**DEPARTMENT OF TRANSPORTATION
STATE OF GEORGIA**

SUBJECT APPROVED REVISED PROJECT CONCEPT REPORT

SUBJECT Revised Project Concept Report – CSSTP-0007-00(537), Muscogee Co.

REVISED PROJECT CONCEPT REPORT

DATE: 5/26/08	SHEET: A20	SOLDIERS MEMORIAL AT COLUMBUS CHAMBER OF COMMERCE COLUMBUS, GEORGIA	PRELIMINARY NOT FOR CONSTRUCTION	Hecht Burdeshaw Architects, Inc. 8-1111 Sweet, Suite 200 • P.O. Box 1756 • Columbus, GA 31902 • 706-323-1814 telephone • 706-327-4419 fax
DESIGNED BY: [Name]	SCALE: [Scale]

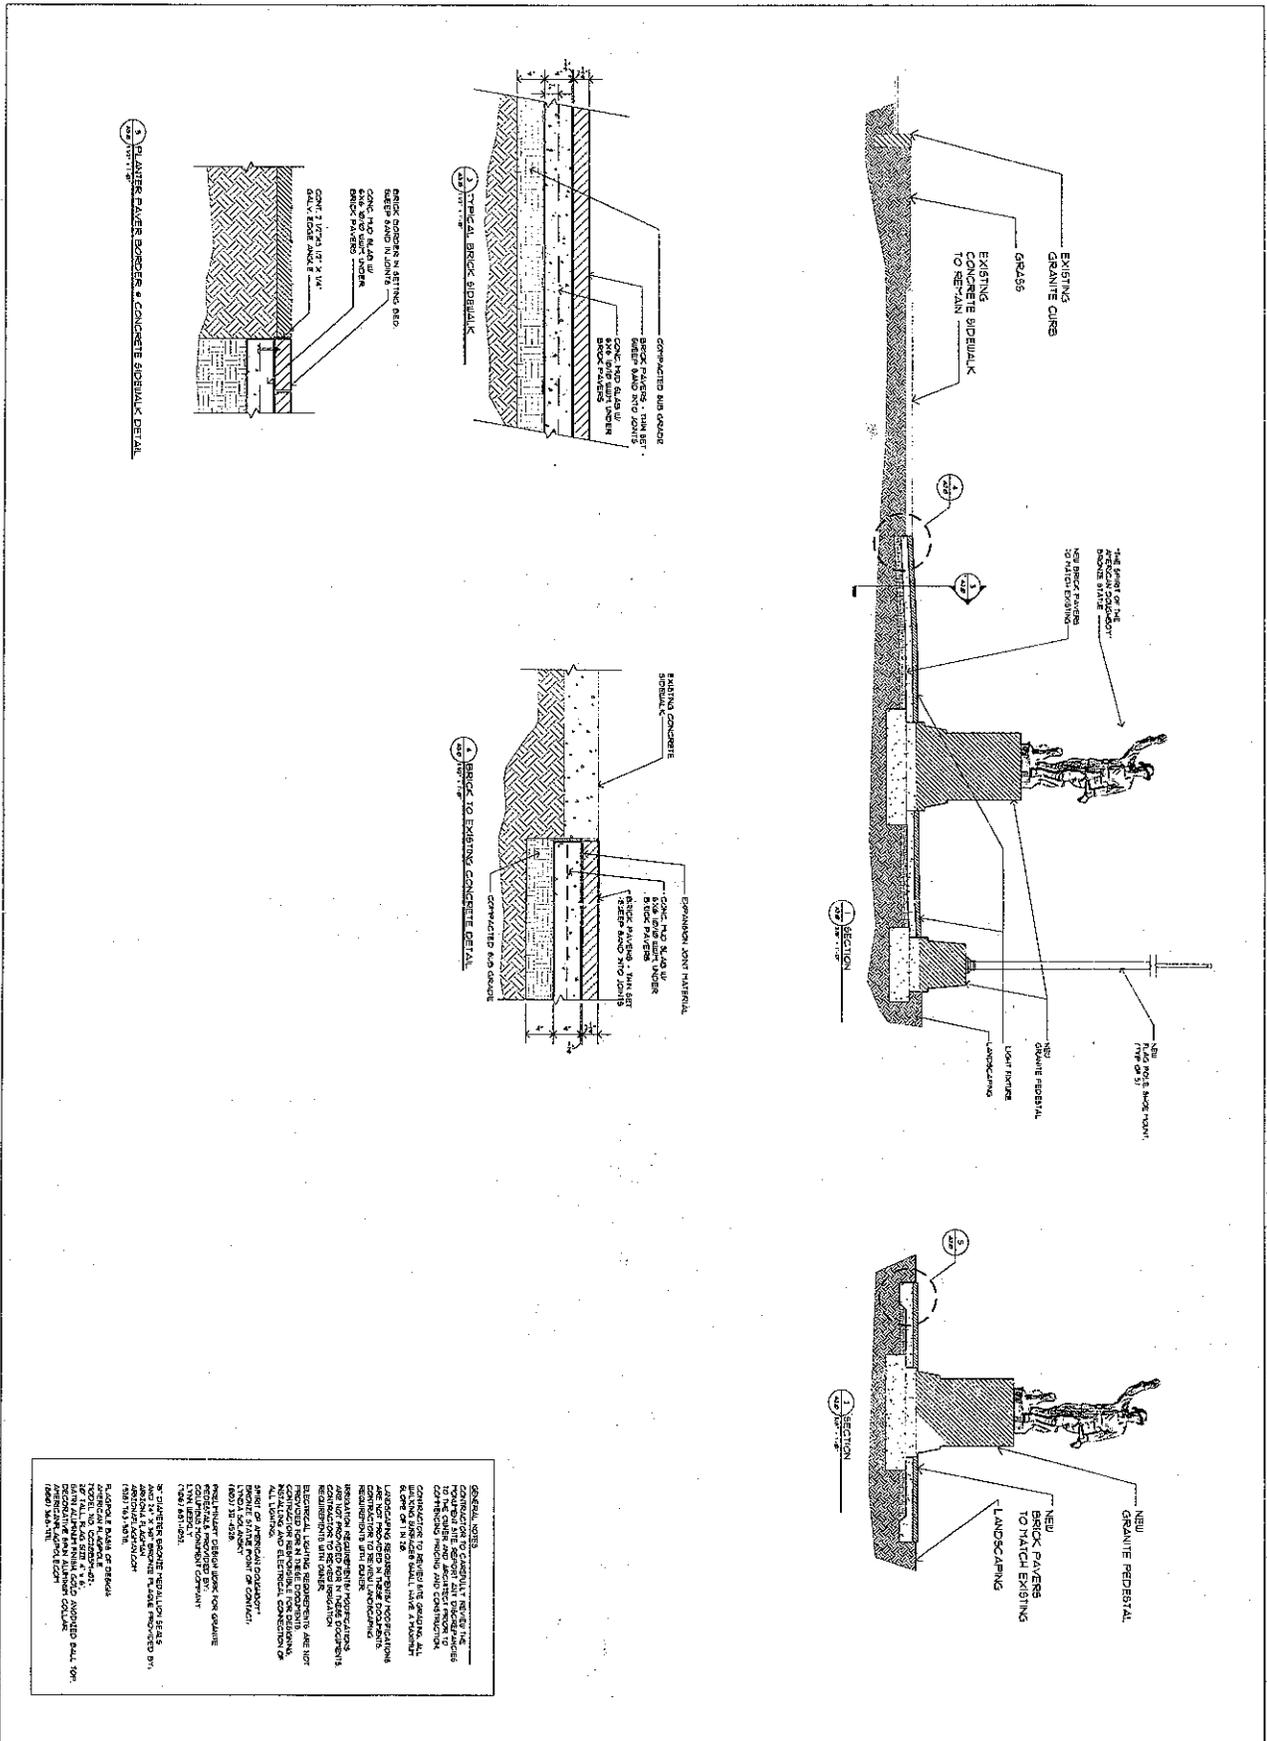
Proposed features to be revised: The addition of the "Military Transportation Memorial Project" and the use of energy efficient lighting for the depot

Describe the revised feature(s) to be approved: *A "Military Transportation Memorial Project" to be constructed to commemorate the importance of the depot as a transportation hub for military operations.*
